RE: Phase II Athletics - **Change Order 07 – Access Controls and Projection Screen Changes**

PROJECT: (Name and address)
Phase II Athletics - Bid Package No. 2 -
NB Field House
Bullitt County Public Schools

CHANGE ORDER INFORMATION:
Change Order Number: 07

PROJECT:	Phase II Athletics - Bid Package No. 2 North Bullitt Field House Bullitt County Public Schools	REQUEST FOR PROPOSAL NO.:	02
OWNER:	Bullitt County Public Schools 1040 Highway 44 East Shepherdsville, KY 40165	DATE:	25-Apr-2025
TO CONTRACTOR:	Calhoun Construction Services, Inc. 7707 National Turnpike Louisville, KY 40218	ARCHITECT:	Studio Kremer Architects 1231 S Shelby Street Louisville, KY 40203
		ARCHITECT'S PROJECT NO.:	2023-50 BG# 24-192

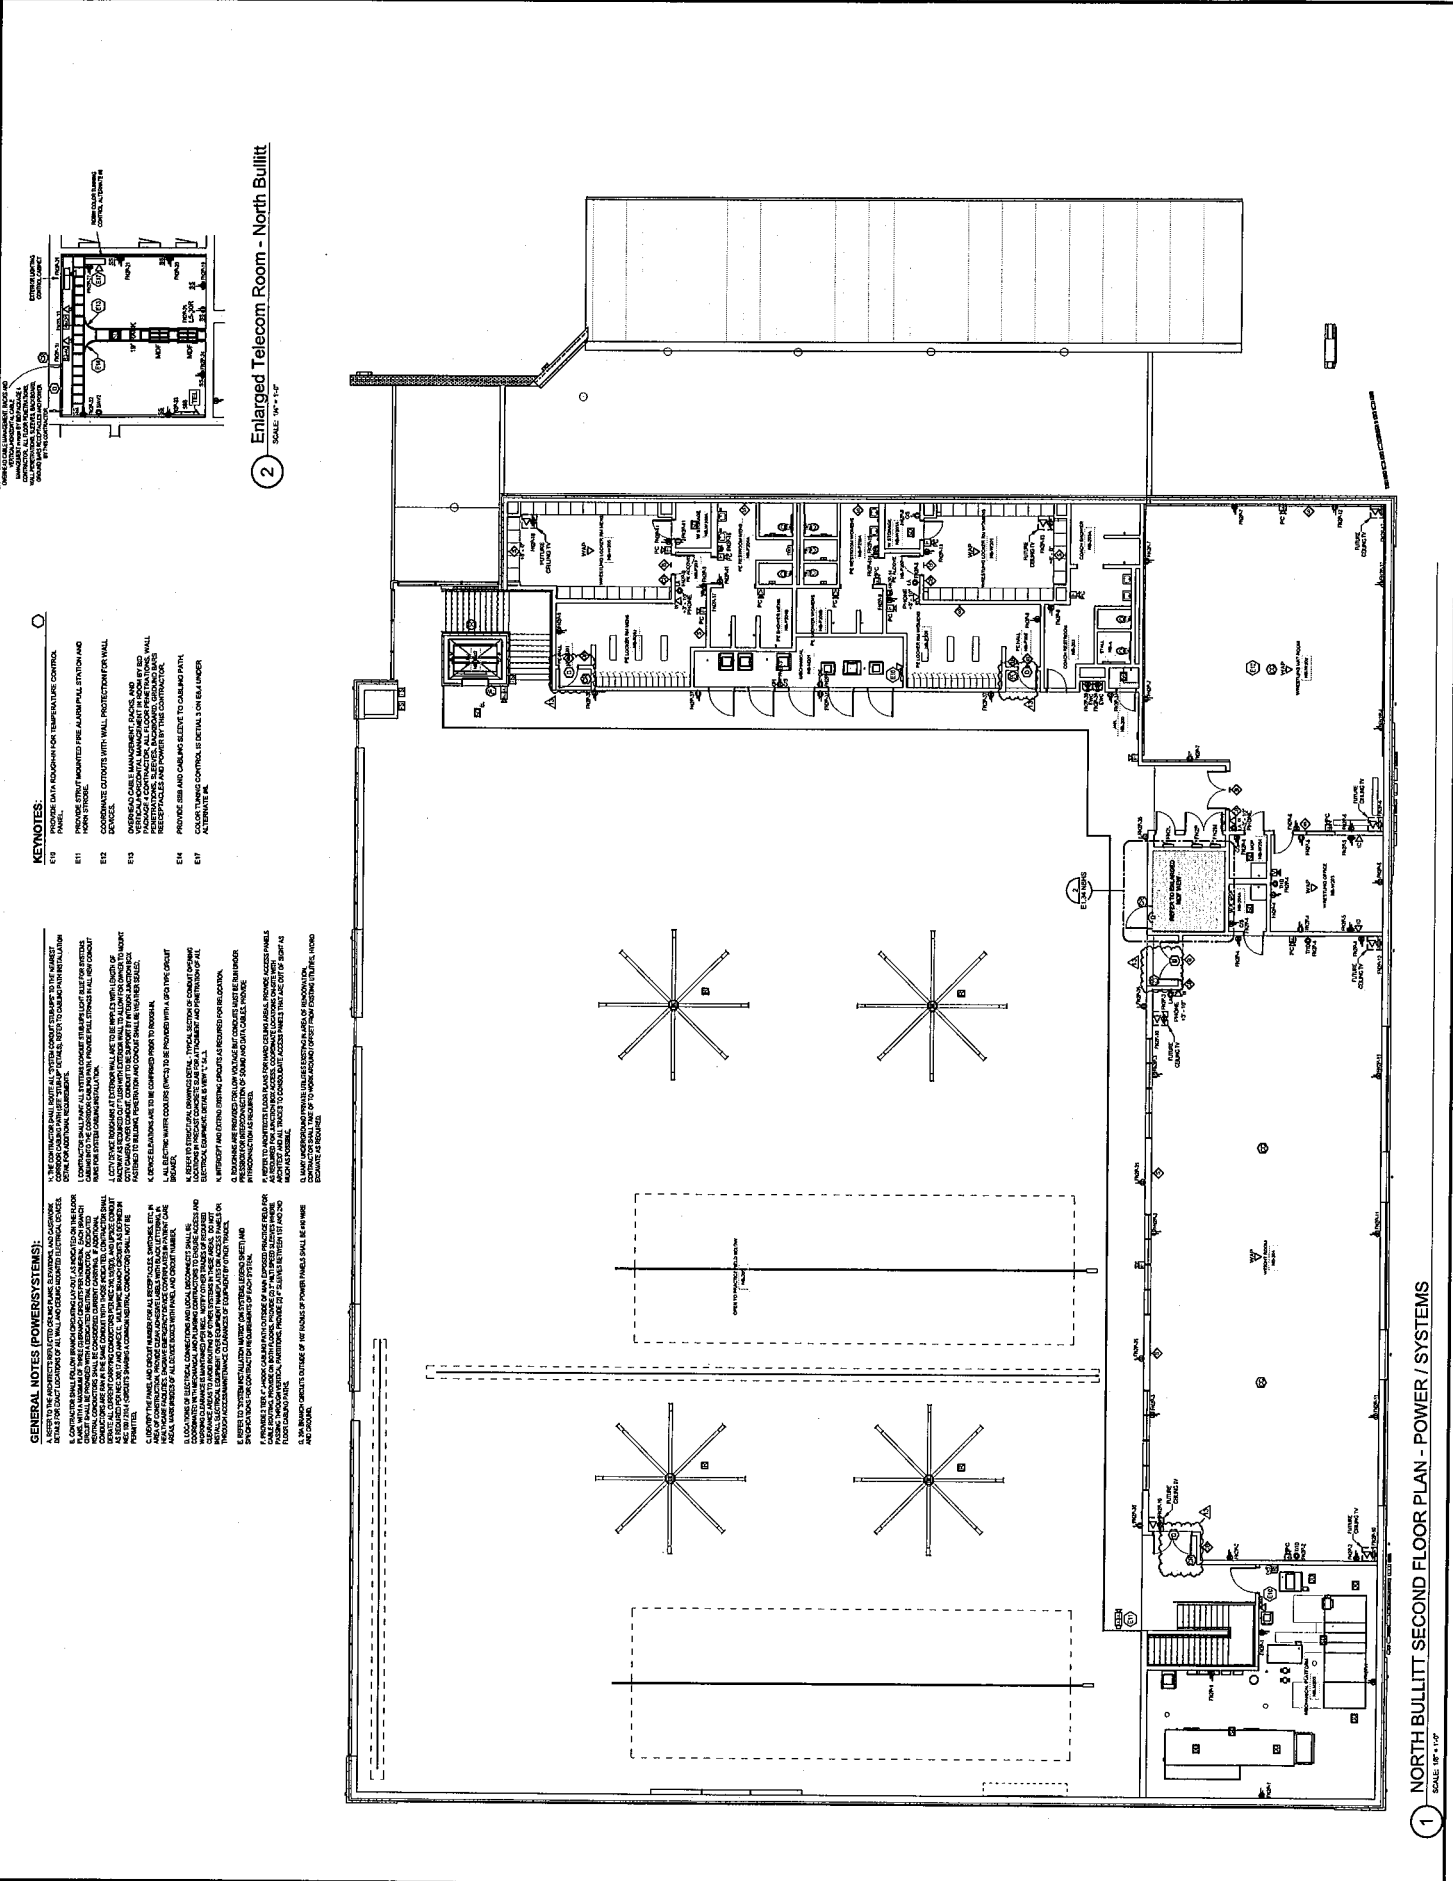
2. Doors NB-204.1 and NB-204.2 were assigned to Hardware Set 04A as follows:

Delete:

(1)	Classroom Security Lock	L9457-17A	626	SCH
(1)	Mortise Cylinder	Primus LFIC 6-pin	626	SCH

Add:***Electrified Items***

(1)	Electric Power Transfer	PTM-2AL		SDC
(1)	Panic Device, Mortise, 03	QEL-9975NL x 697NL	626	VON
(2)	Door Contact, 3/4", Pop-in, DPDT 195-12		White	GRI
(1)	Lot: Card Reader (single-gang), control circuitry, low voltage power, cabling, terminations, programming, etc. (see electrical specifications).

Field prep door and frame for electric power transfer and door contacts. Utilize existing mortise lock and strike preps for new mortise panic device and strike. Turn deleted items over to Owner for stock.

1 NORTH BULLITT SECOND FLOOR PLAN - POWER / SYSTEMS
SCALE: 1/8" = 1'-0"

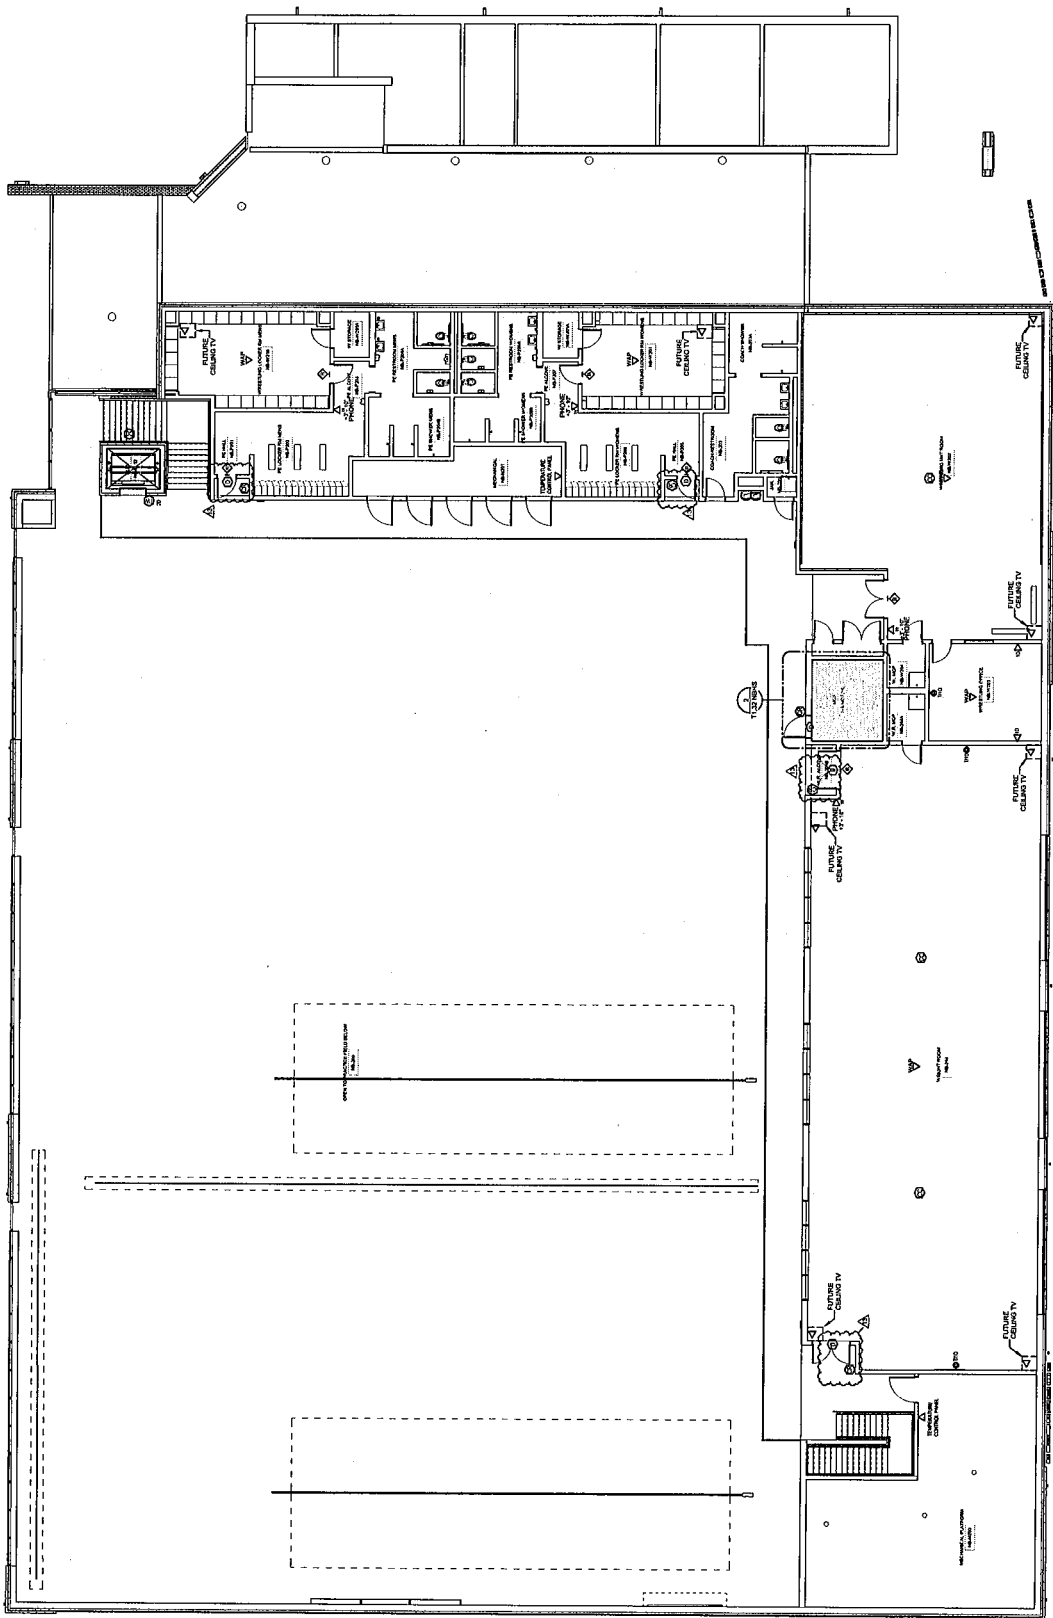
- Item No.1** Refer to A6.03 NBHS:
- Provide access control card reader and door hardware at clouded openings.
- Item No.2** Refer to Spec 08 71 00 Revision - See revisions to HW Sets assigned to Doors NB-P201, NB-P205, NB-204.1 and NB-204.2
- Item No.3** Refer to E1.34 NBHS:
- Provide access control card reader and door hardware rough-ins and stubouts for revised doors.
- Item No.4** Refer to T1.32 NBHS
- Provide access control cabling for revised doors to S2 head end.
